**INDIA'S COMMENTS ON ECE REGULATION NO. 37**

India suggests modification in the current text of the Regulation 37 as follows: (additions are marked in **bold** characters).

**A. PROPOSAL**

**Sheet WY10W/1**

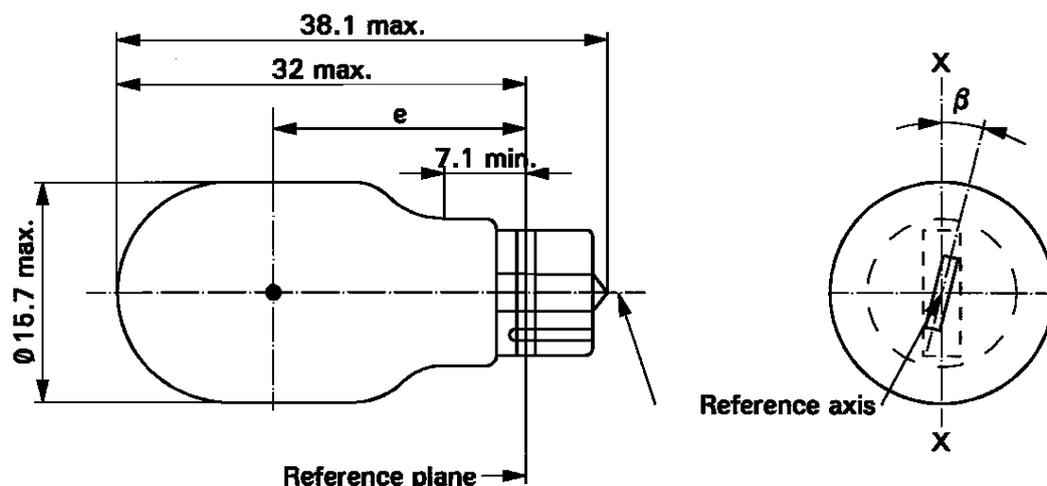
Insert new sheets W10W /1 to 3, between sheet W5W/1 and sheet W16W/1, to read:

Dimensions in mm	Filament lamps of normal production			Standard filament lamp
	min.	nom.	max.	
e	18.3	20.6	22.9	$20.6 \pm 0.3$
Lateral deviation <sup>1/</sup>			1.0	0.5 max.
$\beta$	-15°	0°	+ 15°	$0^\circ \pm 5^\circ$
Cap W3x9.5d – As per the attached drawing. (To be added in IEC Publication 60061)				
<b>ELECTRICAL AND PHOTOMETRIC CHARACTERISTICS</b>				
Rated values	Volts	12		12
	Watts	10		10
Test voltage	Volts	13.5		13.5
Objective values	Watts	11 max.		11 max.
	Luminous flux	75 ± 20 %		
Reference luminous flux at approximately 13.5 V:	White: 125 lm			
	Amber: 75 lm

**Sheet WY16W/1**

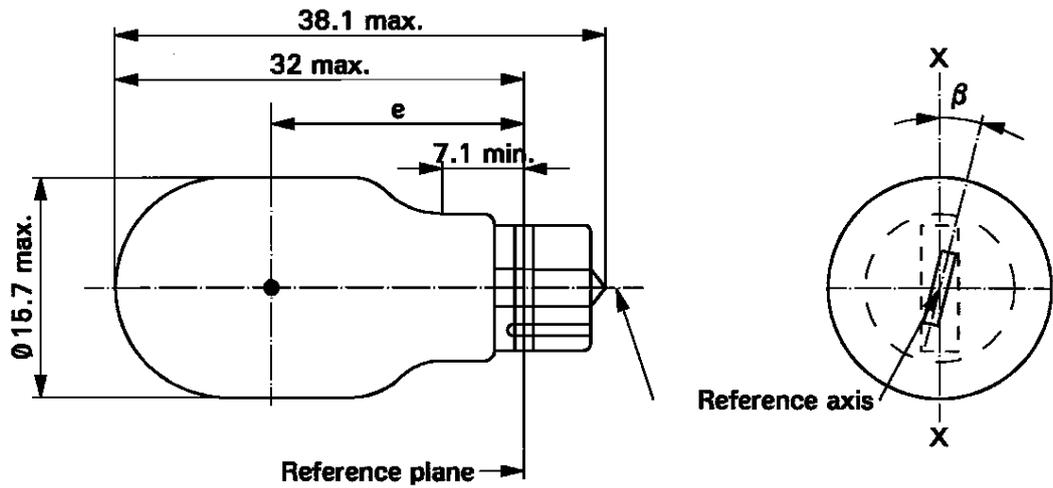
Insert new sheets W10W /1 to 3, between sheet W16W/1 and sheet W21W/1 to 2, to read:

Dimensions in mm	Filament lamps of normal production			Standard filament lamp
	min.	nom.	max.	
e	18.3	20.6	22.9	20.6 ± 0.3
Lateral deviation <sup>1/</sup>			1.0	0.5 max.
β	-15°	0°	+ 15°	0° ± 5°
Cap W3x9.5d – As per the attached drawing. (To be added in IEC Publication 60061)				
<b>ELECTRICAL AND PHOTOMETRIC CHARACTERISTICS</b>				
Rated values	Volts	12		12
	Watts	16		10
Test voltage	Volts	13.5		13.5
Objective values	Watts	21.35 max.		21.35 max.
	Luminous flux	189 ± 20 %		
Reference luminous flux at approximately 13.5 V:	White:	310 lm		
	Amber:	189 lm

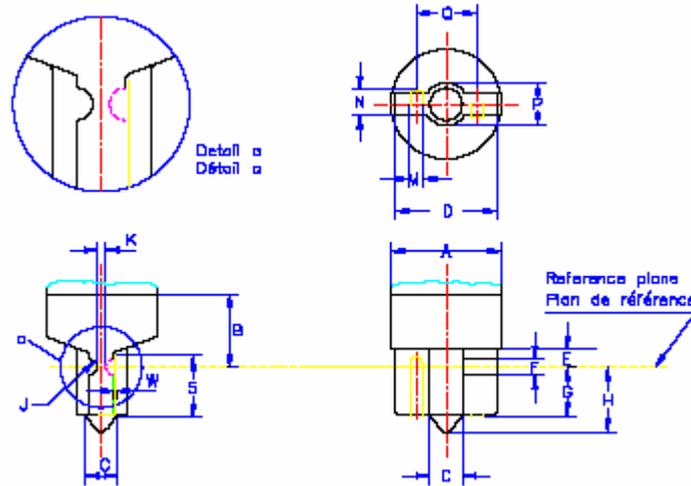
A suitable cap, not interchangeable with white lamp does not exist in IEC. It is proposed that, the cap as per the details may be incorporated in IEC 60061.

Standard dimensions		
Dimensions	Min.	Max.
A	--	10,29*
B	6,86*	--
C (1)	--	3,95
D	8,90	9,50
E	1,65	--
F*	Nom. 1,52	
G	3,4	4,6
H	--	6,10
J*	Nom. 0.76	
K*	Nom. 0.76	
M*	Nom. 1,52	
N	2,80	3,30
P	--	4,96
Q	Approx 5,6	
S	4,83	--
W	---	0,36
